CAL FCC 47-002

Subject: Incorrect Fuel Tank Support Rods

Model: Tiffin XCR

Subject: Replacing Fuel Tank Support Rods

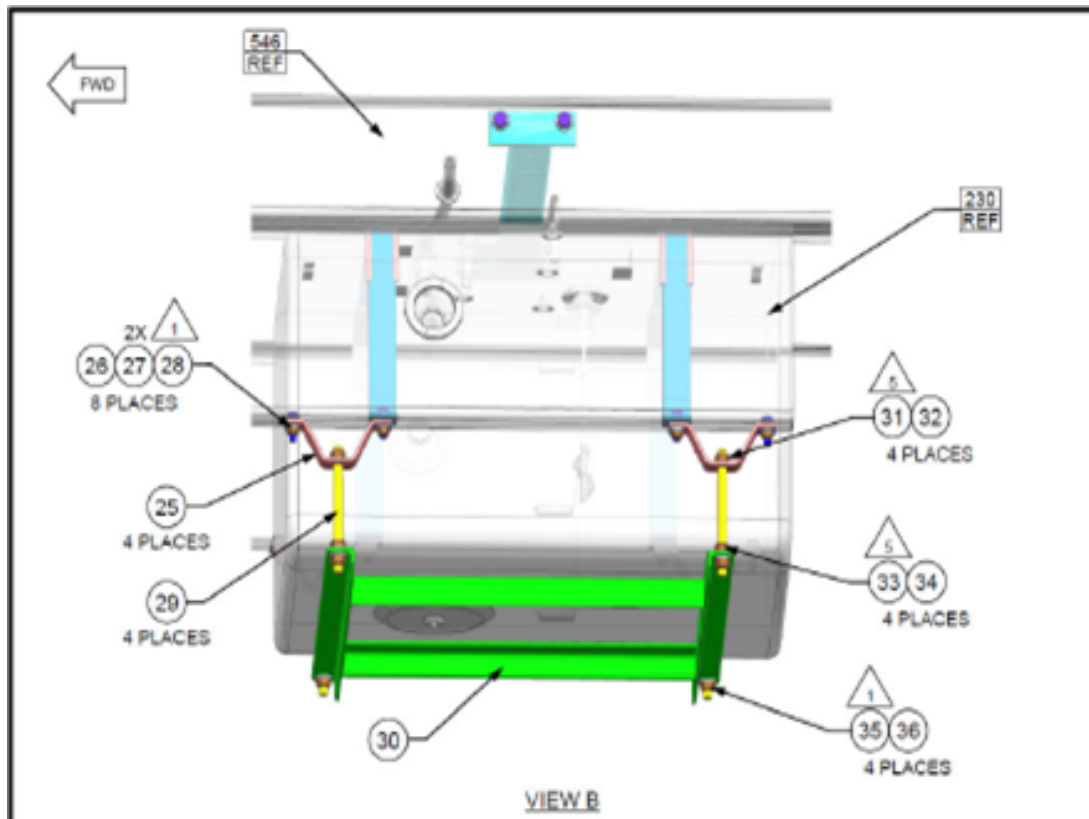
The fuel tank support rods installed on your vehicle may be incorrect and need to be replaced.

1. Park the vehicle, shut down the engine, and apply the parking brakes. Chock the tires.
2. Support the fuel tank cradle.
3. Remove the currently installed fuel tank support studs.
4. Install the correct studs, PN 03-25287-009, per drawing D03-44520-000. Install the upper end of the stud to the fuel tank support on the chassis rail and place the washer and fastener on top.

5. Place the fastener and washer onto the stud, then insert them through the fuel tank cradle.
6. Place the washer and fastener at the bottom of the stud and tighten the fastener 118 lbf·ft (160 N·m). Repeat this process at four places for each fuel tank support stud.
